APPLICATION
 For Planning Board and Zoning Board of Appeals Approval

Application Submission Supplement

343-351 Summer Street

The following supplement addresses comments raised by the Office of Strategic Planning and Community Development on January 20, 2010:

Proposed Wall Assembly for VFW Post

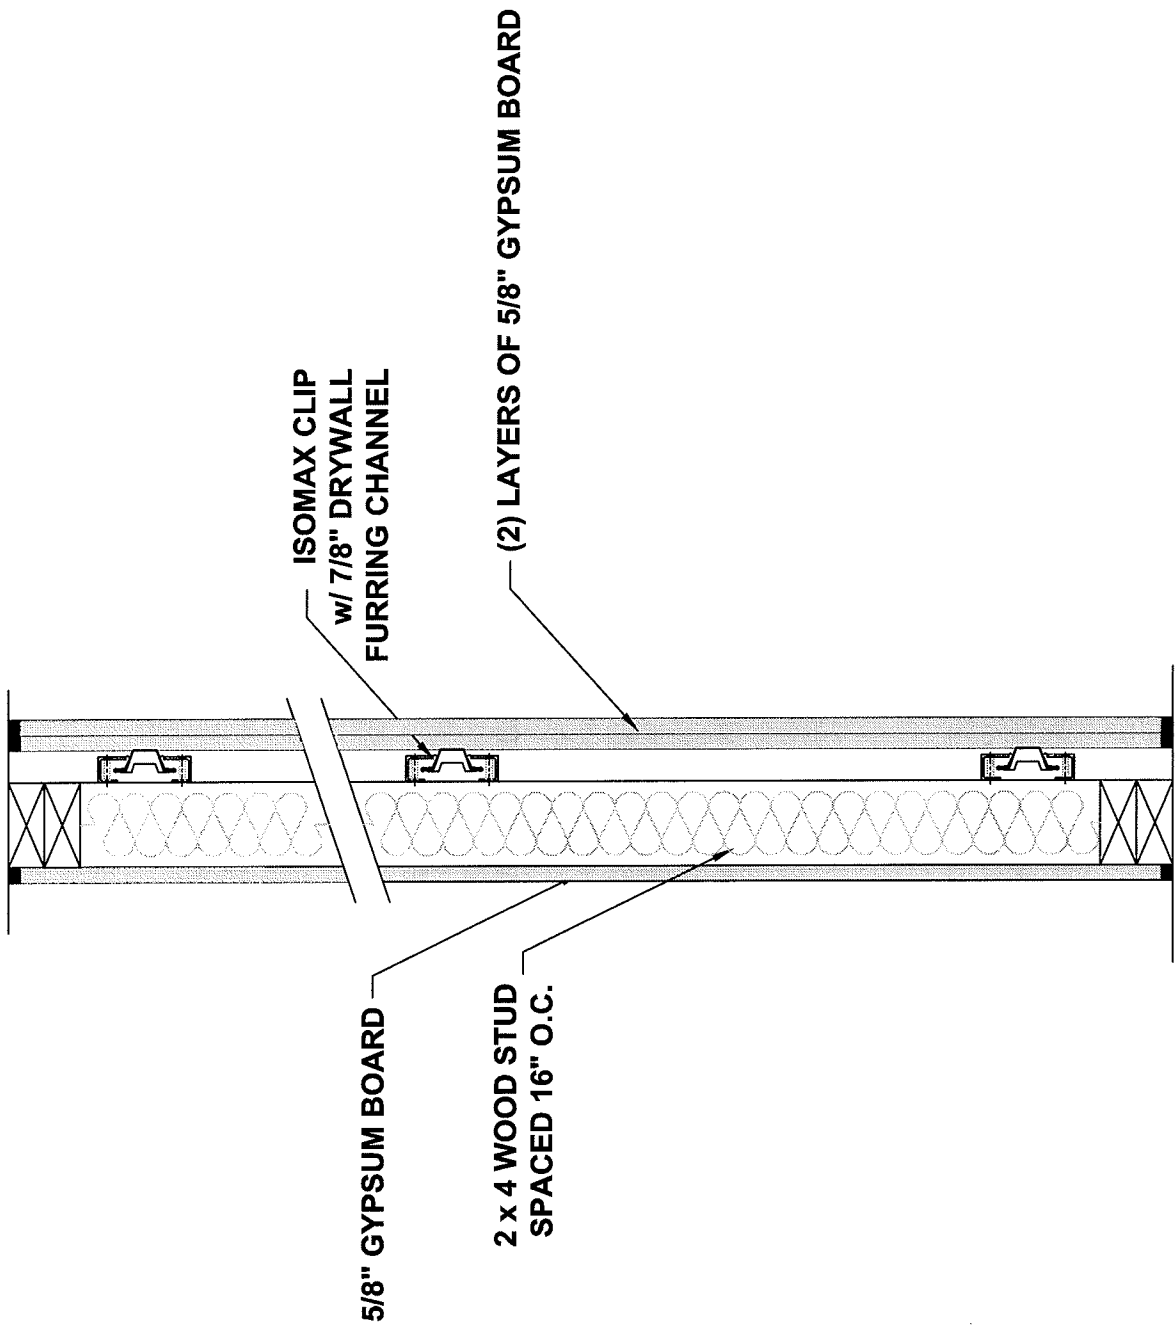
- 8) **Soundproofing** - Indicate what soundproofing measures will be undertaken for the VFW on drawings.

See proposed wall assembly attached herewith in Exhibit 2

The proposed exterior wall assembly for the new VFW Post will be similar to those shown in the attached samples. Both samples exceed code requirements.
